Comments: B20001683

10621 Gorman Rd  
Laurel, MD 20723

Revision to Site plan  
for B20001683 to  
include location of  
Septic tank as requested  
by Hank Oswald

REVISION

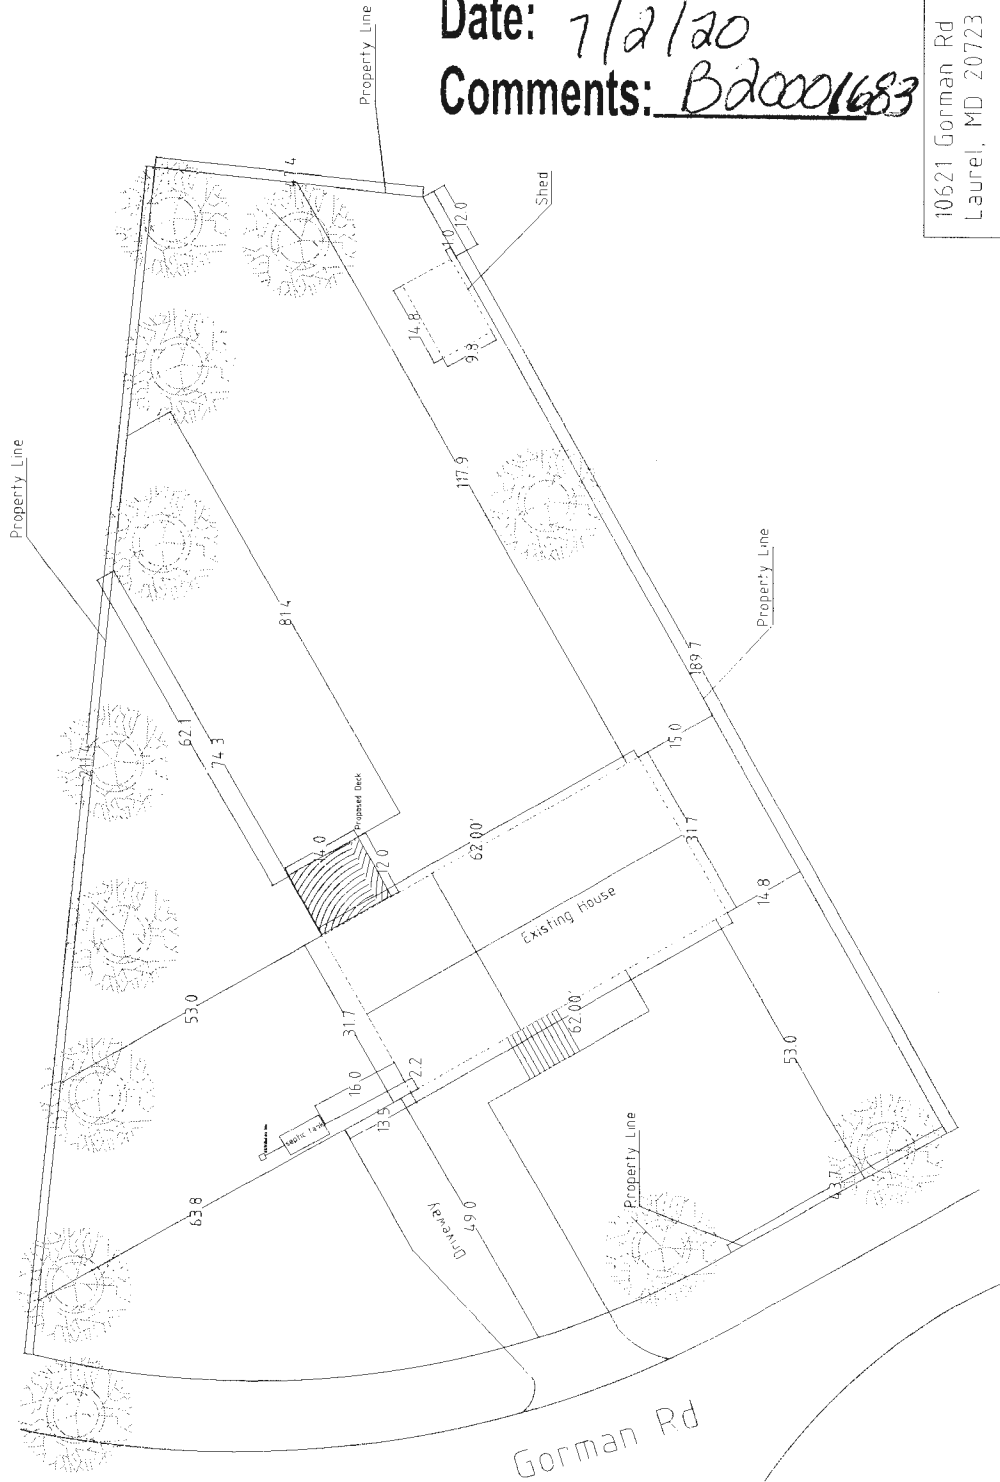
Thanks. Please submit the updated plan to the permits office. Are you connected to public water? - Hank

Thank you for speaking with me last week. Please find the updated site plan attached to this email that includes the location of the septic tank. Please advise if this looks sufficient for the county's needs, and if so I will go ahead and mail in a hard copy or upload to the drop box.

Good morning. Your building permit has been approved by the Health Department.
